| <b>AMENDMENT OF SOLICITATION/MODIFICATION OF CONTRACT</b>  |                                  |   | 1. CONTRACT ID CODE<br>J                              | PAGE OF PAGES<br>1   5              |
| 2. AMENDMENT/MODIFICATION NO.<br>0011  | 3. EFFECTIVE DATE<br>05-May-2016 | 4. REQUISITION/PURCHASE REQ. NO.  |   | 5. PROJECT NO.(If applicable)       |
| 14. DESCRIPTION OF AMENDMENT/MODIFICATION (Organized by UCF section headings, including solicitation/contract subject matter where feasible.)<br><br>The purpose of this amendment is to provide clarifications to previously answered RFIs.   |                                  |   |   |                                     |

AMENDMENT 0011

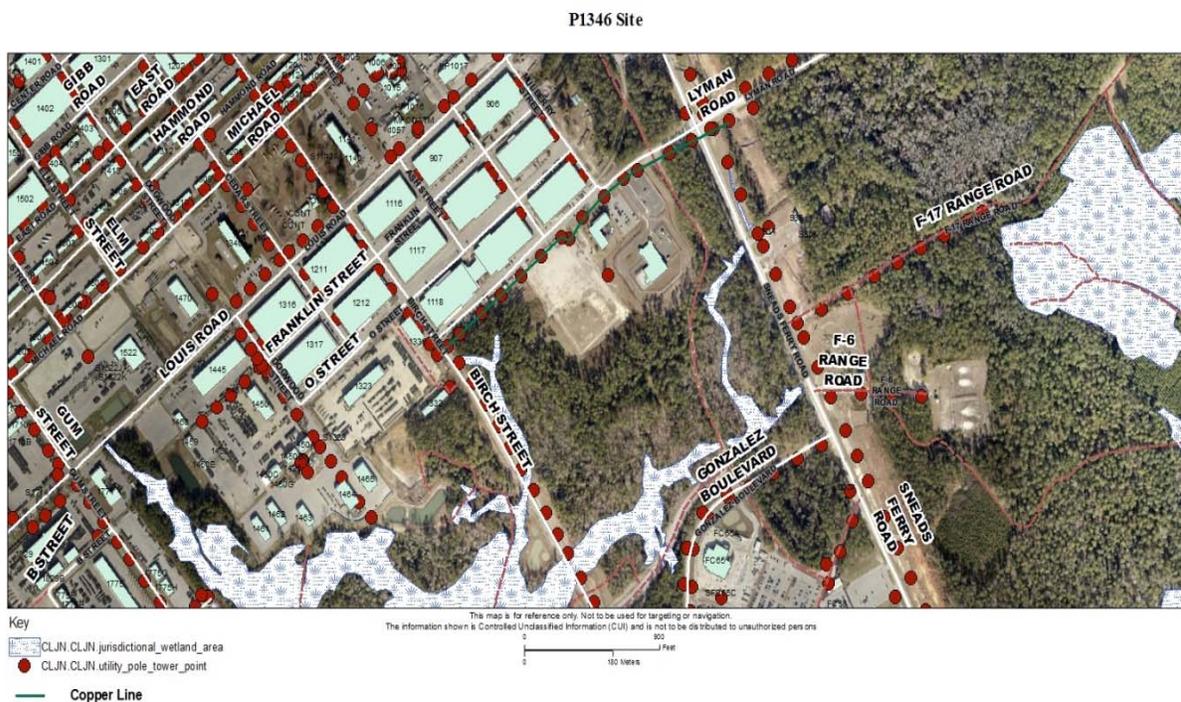
10. Amendment 0009, G4010 Electrical Distribution - Where is the connection for the “new overhead 13.2KV, three phase, four-wire, 60 Hertz electrical power system.”

11. Amendment 0009, G4010 Electrical Distribution – This section states, “Upgrade approximately 2500 LF of existing overhead copper conductors and all associated poles,” which pole line will be upgraded? (We need to know if the existing and the replacement pole lines are installed though adverse conditions, such as a swamp, or if they are installed in adequate conditions, such as paved areas.) Please provide a plan for the existing route.

12. Amendment 0009, G4010 Electrical Distribution – Please provide the number of buildings that are currently powered by the existing pole line, or what size service will be required for the upgrade?

**RESPONSE:** See attached graphic. Connect to the 12.47KV system at pole XX located at intersection of Sneads Ferry Rd and Duncan St. Also, connect to existing tie point approx. 2500 LF, Southwest down Duncan St.

**Response: See attached graphic, above. There are no adverse conditions.**

**RESPONSE: x riser poles (underground terminal), x overhead taps. See attached graphic.**
